ADDENDUM NO. 2 TO PROJECT NO. 43188

**CONSTRUCTION WORK
WATERPROOF GRAND STAIRCASE BETWEEN CEC AND PLAZA
EMPIRE STATE PLAZA
ALBANY, NY**

March 27, 2014

K1 SECOND FLIGHT INSTALLATION PLAN
SCALE 1/8" = 1'-0"

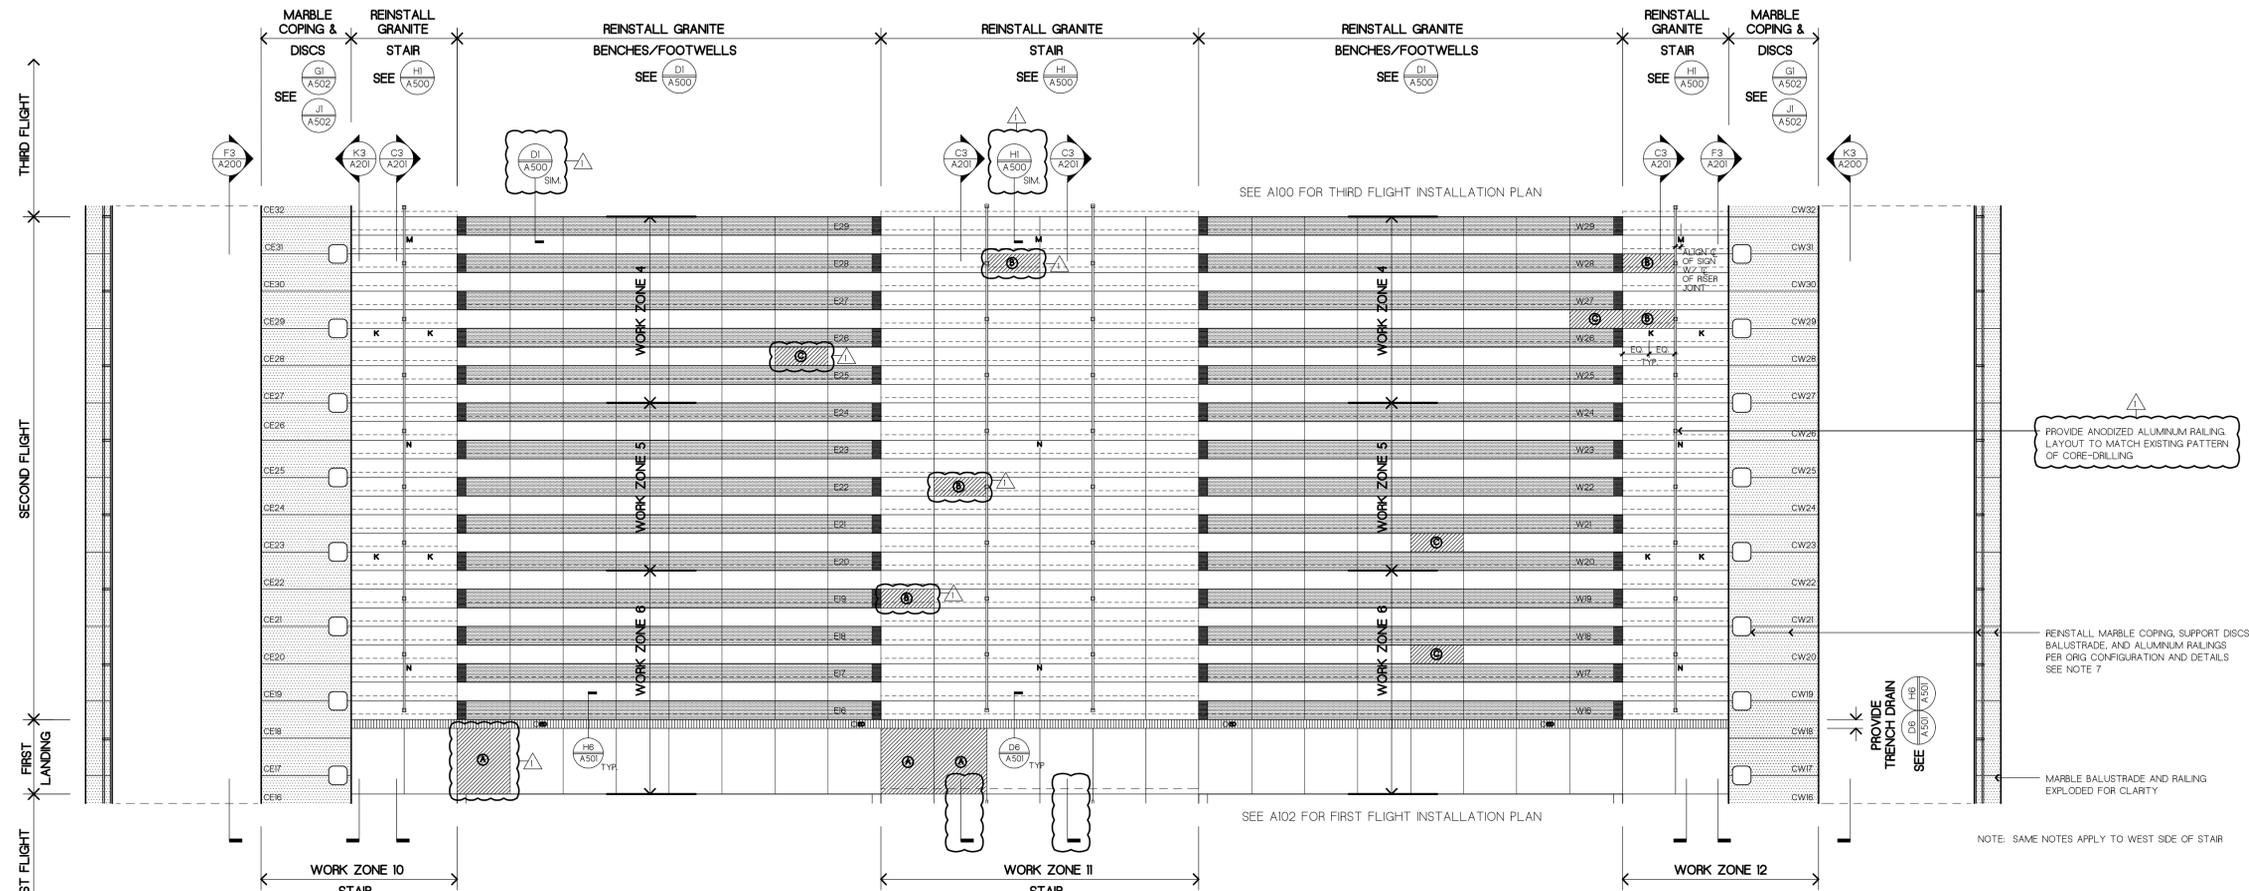
18. Revised Drawings:
 - a. Drawing Nos. A101, and D500, noted “REVISED DRAWING 3/26/14” accompany this Addendum and supersede the same numbered originally issued drawings.

D10 TYPICAL STAIR TREAD REMOVALS (CENTER AISLES)
 SCALE: 1-1/2" = 1'-0"

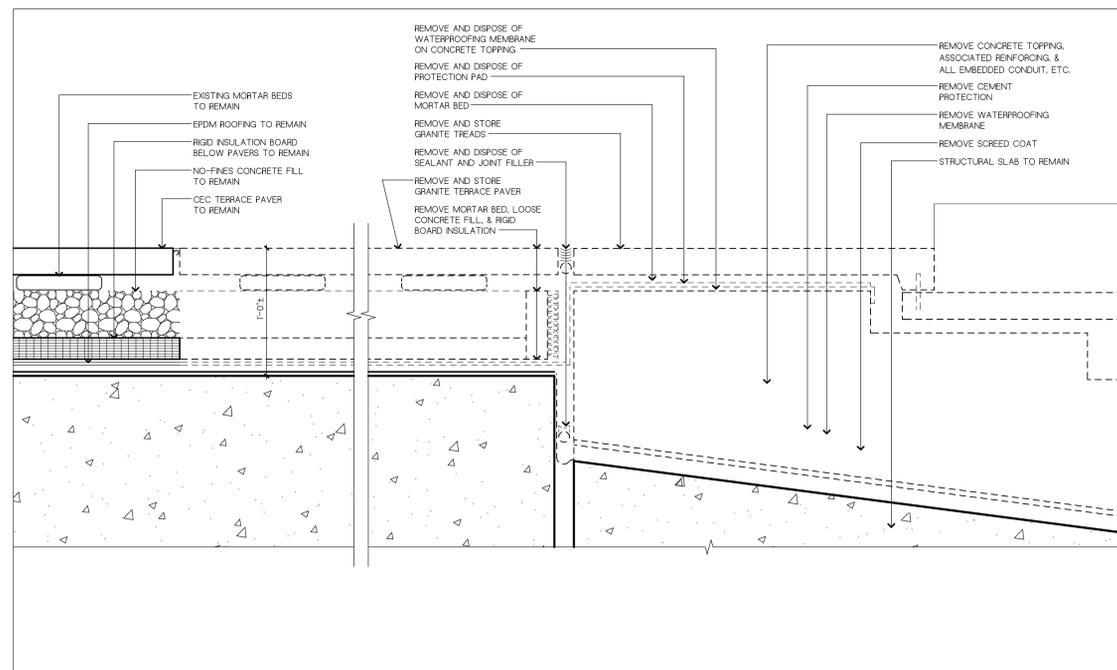
17. Drawing No. D501, Detail D10/D501: Change Detail Title, “Typical Handrail Removal Detail (Center Aisle)” to read “Typical Handrail Removal Detail.”
